Access Compliance Report

Public Rights-of-Way

(Curb Ramps)

Intersection ID: 12728	Main Street: E_10TH_ST	Cross Street: SEIGLE_AV	Location: N
ADA ID: 81A7CD5171AA	Ramp Type: BlendTrans1	Initial Pass/Fail: Pass	Overall Compliance: No
Severity Score: 7.75			
Codes/Mitigation Info/Possible Solution		Field Measurements/Component Compliance

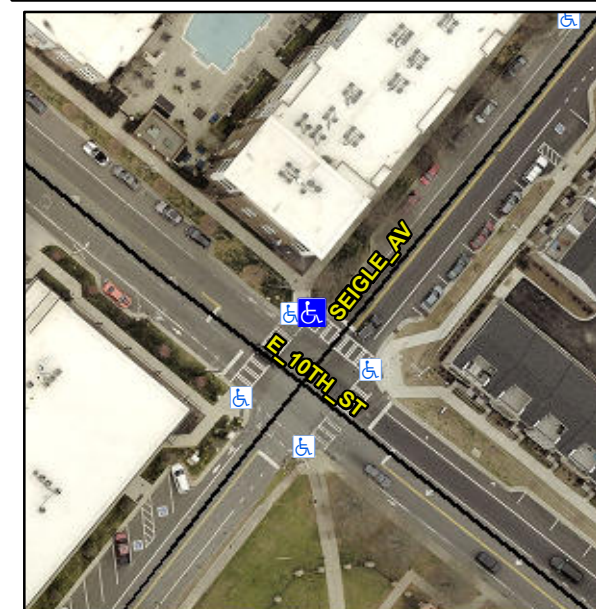
Not Found, R304.5.3, R305.2, R302.7.2

Compliance	Description	Data	Compliance	Description	Data
N/A	Ramp Length (in)	77.0	Yes	BlendTrans Slope (%)	2.9
Yes	Ramp Width (in)	70.5	No	BlendTrans XSlope (%)	3.6
Yes	Flare Type LCurbed_NoWalkSurface	Yes	Yes	Flare Type RCurbed_NoWalkSurface	Yes
N/A	Flare Slope LT (%)	N/A	N/A	Flare Slope RT (%)	N/A
N/A	Flare Traversable LT?	No	N/A	Flare Traversable RT?	No
Yes	Landing Length (in)	60.0	Yes	DWS Provided?	Yes
Yes	Landing Width (in)	53.0	Yes	DWS Contrast?	Yes
Yes	Landing Slope (%)	1.0	Yes	DWS Length (in)	24.0
Yes	Landing X Slope (%)	1.8	Yes	DWS Full Width?	Yes
N/A	Landing Curb? (Y/N)	No	No	DWS Offset (in)	7.0
N/A	Shared Landing?	Yes			
Yes	Gutter Ponding?	No	Yes	Gutter Slope (%)	1.1
No	Gutter Lip Ht (in)	0.3	No	Gutter X Slope (%)	4.2
N/A	Painted X Walk1?	Yes	N/A	Painted X Walk2?	N/A
	X Walk 1 Direction	To SE		X Walk 2 Direction	N/A
	X Walk 1 Width (in)	110.0		X Walk 2 Width (in)	N/A
	X Walk 1 Slope (%)	4.1		X Walk 2 Slope (%)	N/A

X Walk 1 X Slope (%)	2.6		X Walk 2 X Slope (%)	N/A
Yes	Ramp inside XWalk1?	Yes	N/A	Ramp inside XWalk2?	N/A
	Road Slope (%)	2.6		Clear Space?	Yes
	Road X Slope (%)	4.1	N/A	Clear Space to XWalk (in)	N/A
Yes	Any Obstructions?	No	Yes	Storm Grate/Utility Hazard?	No
	Obstruction Type			Storm Grate/Utility Type	
		N/A			N/A
			Yes	Surface Condition? (G/P)	Good
			No	Curb Slope (%)	10.3

Remove & Replace Curb Ramp With Two New Directional Ramps or Equivalent. Remove & Replace Gutter.
